**DRAINAGE STUDY
FOR
VISTA II BALLFIELDS
(PRELIMINARY ENGINEERING)**

Job Number 19253-B

This Drainage Study presents a revision to the October 16, 2023 report pursuant to the County of San Diego plan check comments received January 24, 2024. The following text identifies the plan check comments along with the responses in bold.

Ground

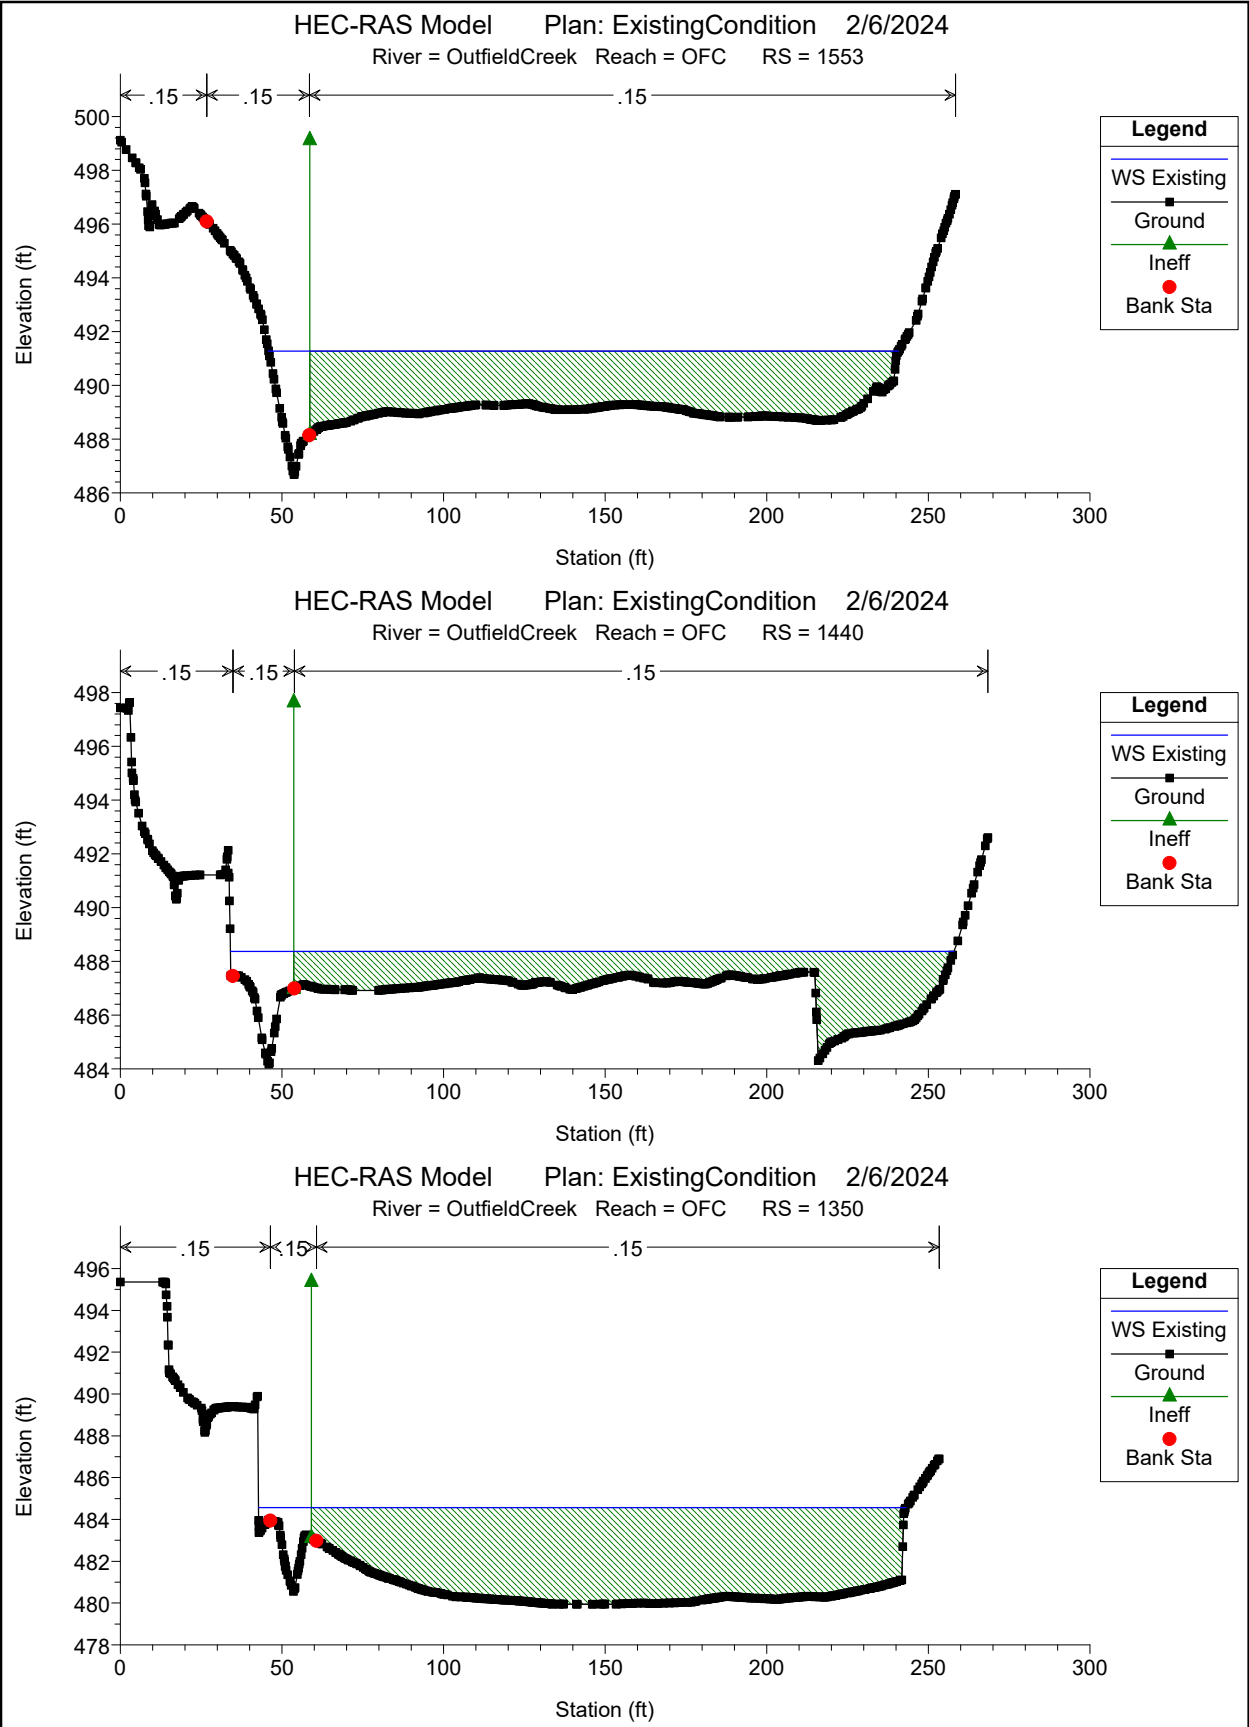
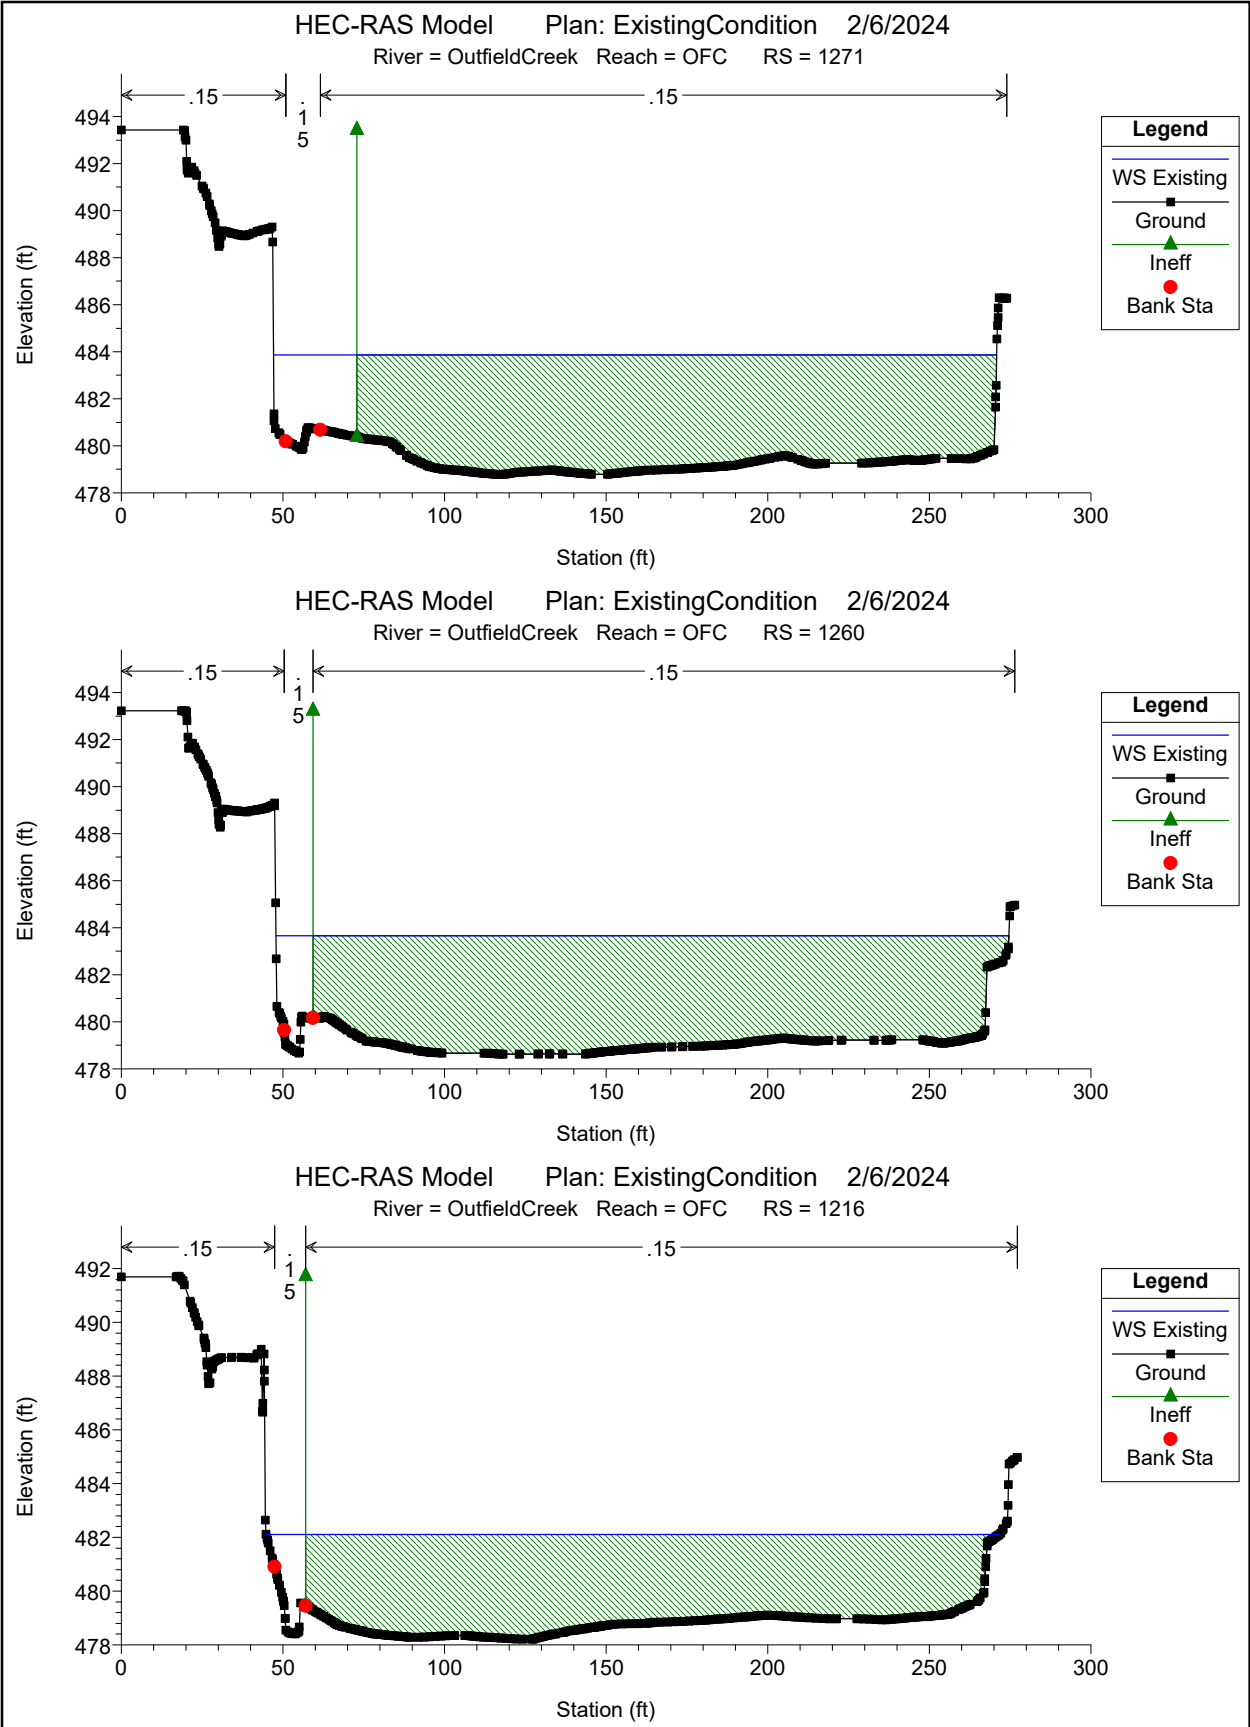
Based on a call with the County of San Diego on April 11th, 2024, it was requested to show the lot lines for the proposed project on the Hydraulic workmap to show in the limited locations where we see an increase in water surface elevation that it is contained within the proposed project's property limits. Additionally, a note has been added to the exhibit to acknowledge that for one upstream cross-section (1899) that extends beyond the property limits only a 0.01-ft increase is recorded which, considering the limits of the model, effectively rounds to 0.0-ft. The table shows results to two decimal points to be consistent with the HEC-RAS model output.

7-33b. 3rd Review Comment: The values for the water surface elevation appear to indicate an increase at certain stations. Due to increase in water surface elevation for the existing channel, document if the increase is contained on the project's private property or if the increase will impact existing neighboring property owners.

Response: The water surface elevations and HEC-RAS model has been revised. Any increase to WSEL is contained within the project's private property.

1. THERE IS AN INCREASE IN WATER SURFACE ELEVATION AT CROSS-SECTION 1105. HOWEVER, THIS INCREASE IS WITHIN THE LIMITS OF THE PROJECT AND DOES NOT EFFECT OTHER PROPERTIES. OTHER CROSS-SECTIONS AT THE UPSTREAM END OF THE PROJECT (1899, 1868, 1863, AND 1758) SHOW AN INCREASE OF LESS THAN 0.05-FT. WHICH GIVEN THE LIMITATION OF THE MODELING SOFTWARE, SHOULD EFFECTIVELY ROUND TO 0.0-FT. THE TABLE HAS BEEN SHOWN TO TWO DECIMAL PLACES FOR CONSISTENCY WITH THE HEC-RAS OUTPUT.

**DRAINAGE STUDY MAP FOR VISTA II BALLFIELDS
PRE-PROJECT**

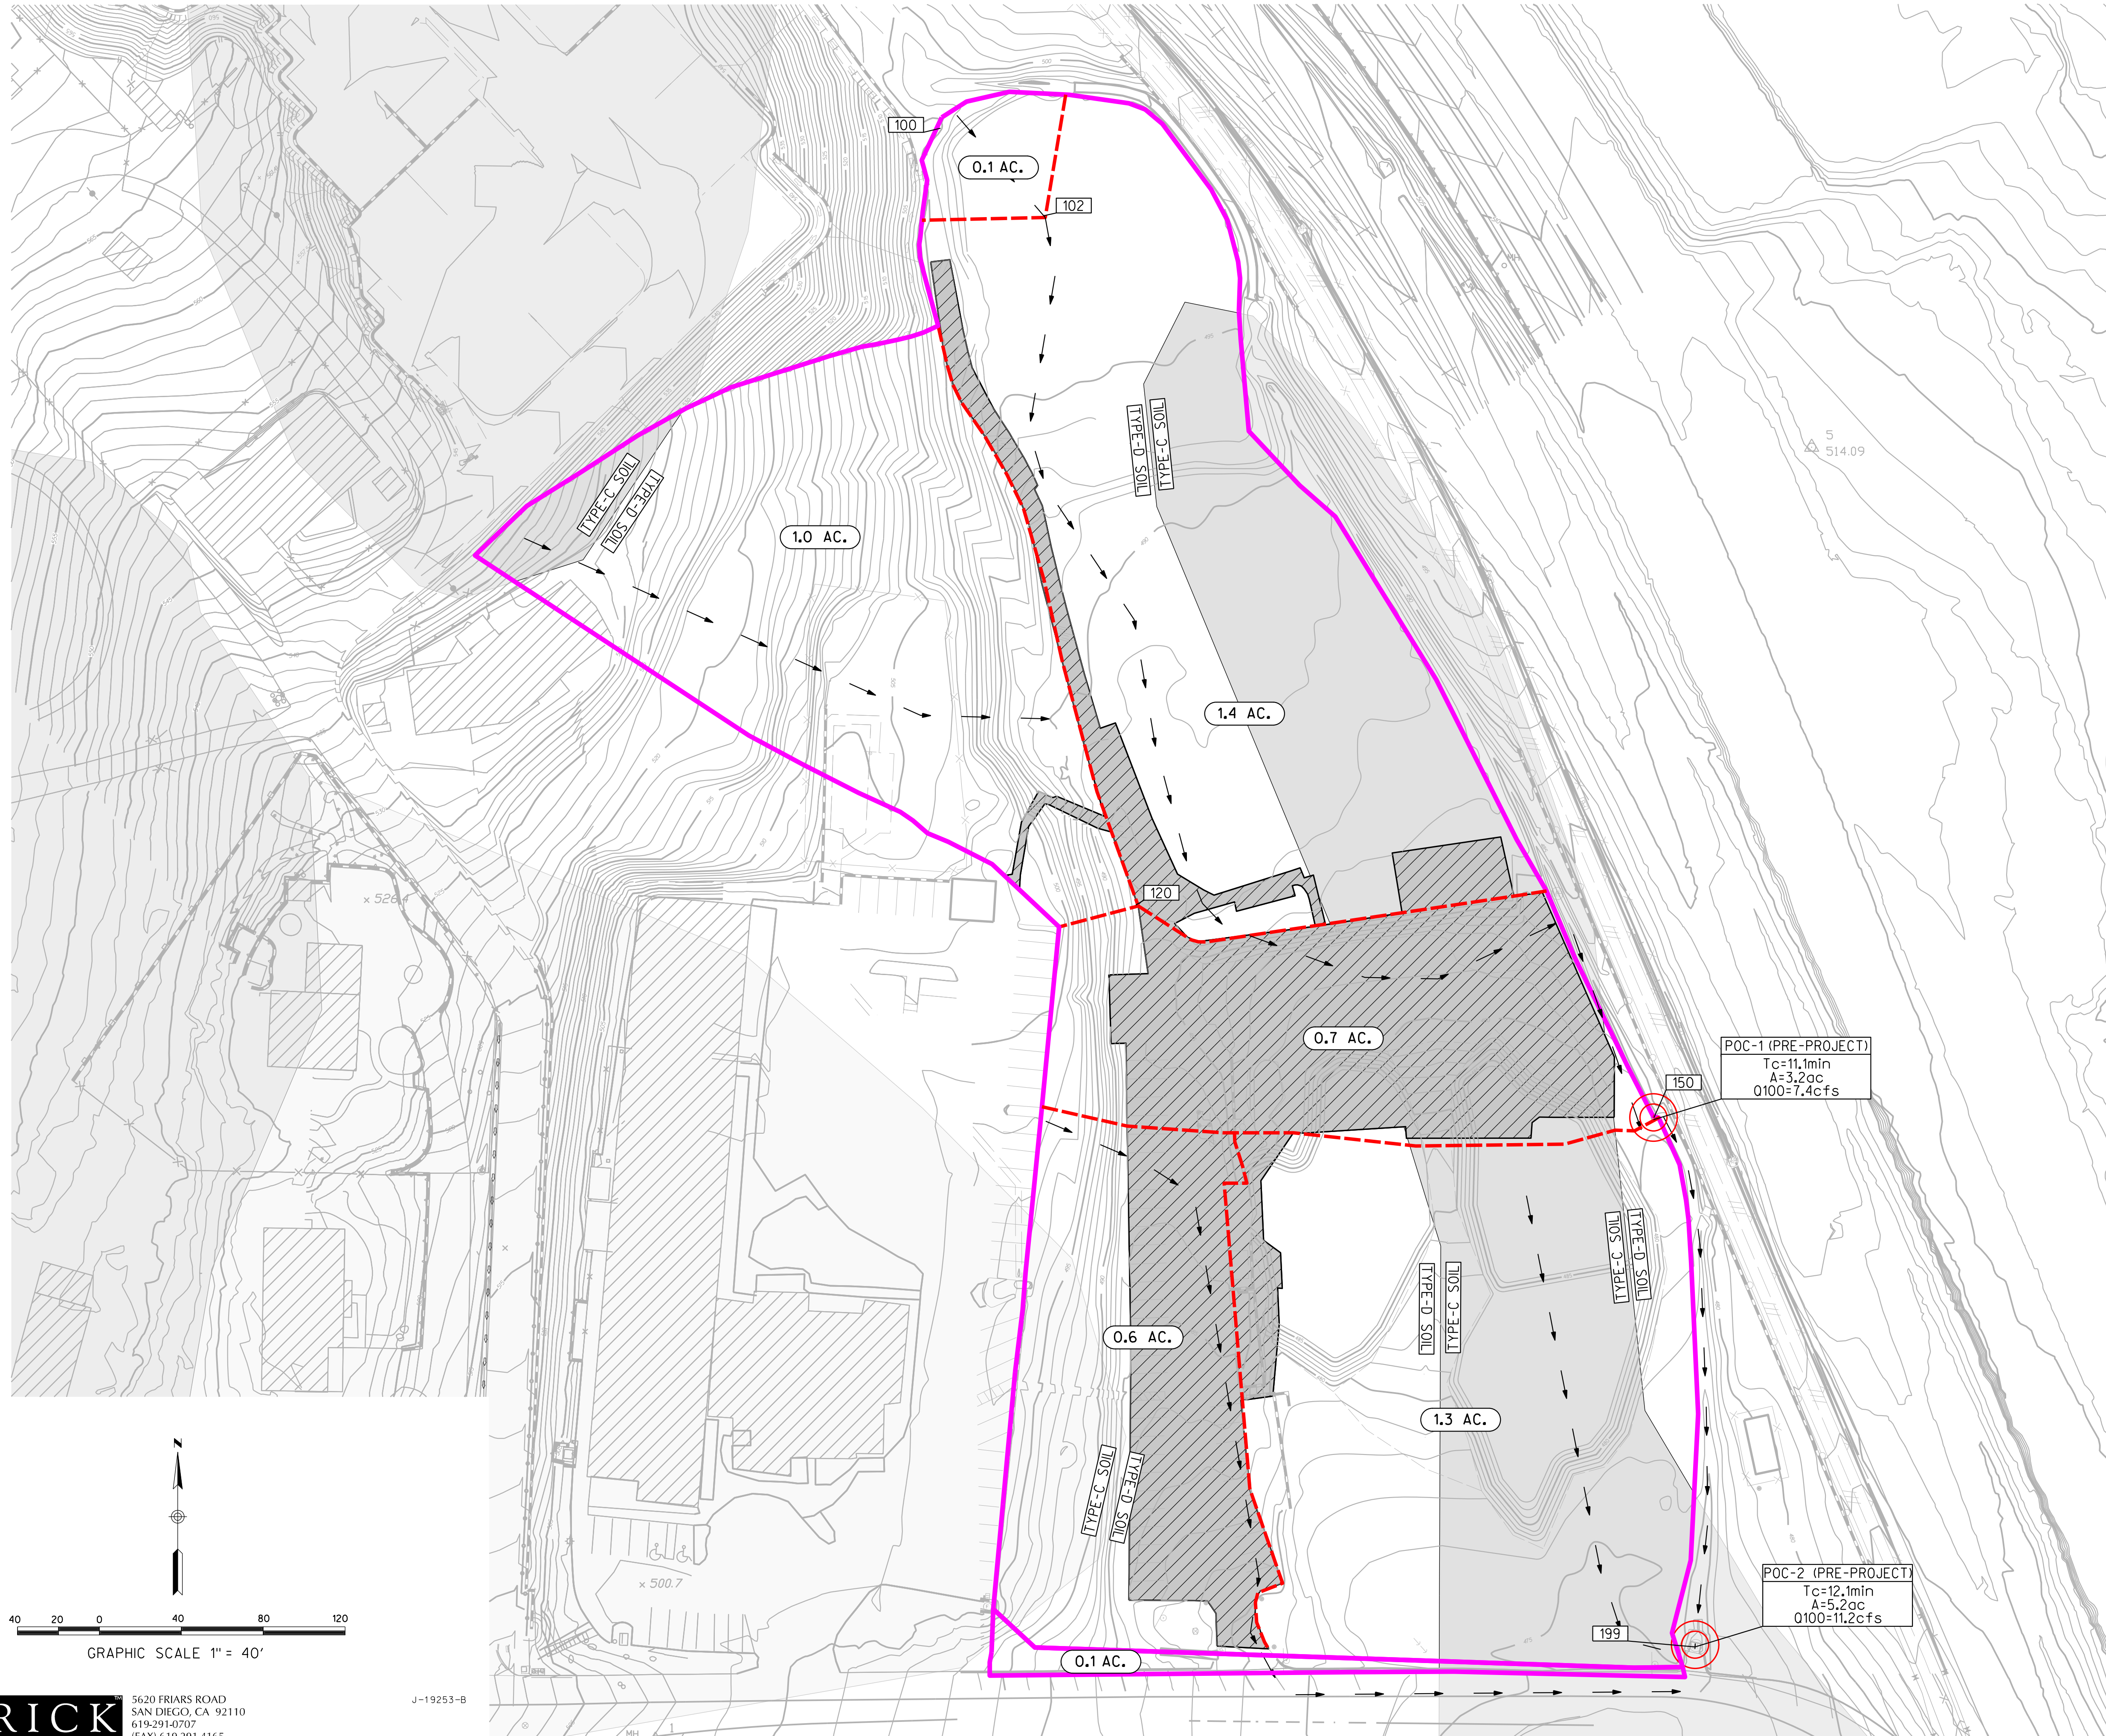
7-35. 3rd Review Comment: Update the Tc, A, and Q100 values for POC 2 in the Pre-Project Drainage Study Map to be consistent with the summary table and analysis in the report.

7-36. 3rd Review Comment: Both the Pre-Project and Post-Project Drainage exhibits do not indicate the 0.1 subbasin for the right of way public improvements, but the area appears to be included in the analysis.

Revise to show this area in both maps.

Response: The pre-project drainage study exhibit has been updated to be consistent with the summary table in the Drainage Study.

Response: The area representing the right of way public improvements has been added to the pre-project and post-project drainage exhibits.

Response: The pre-project exhibit has been updated to show soil from the Vista I project.
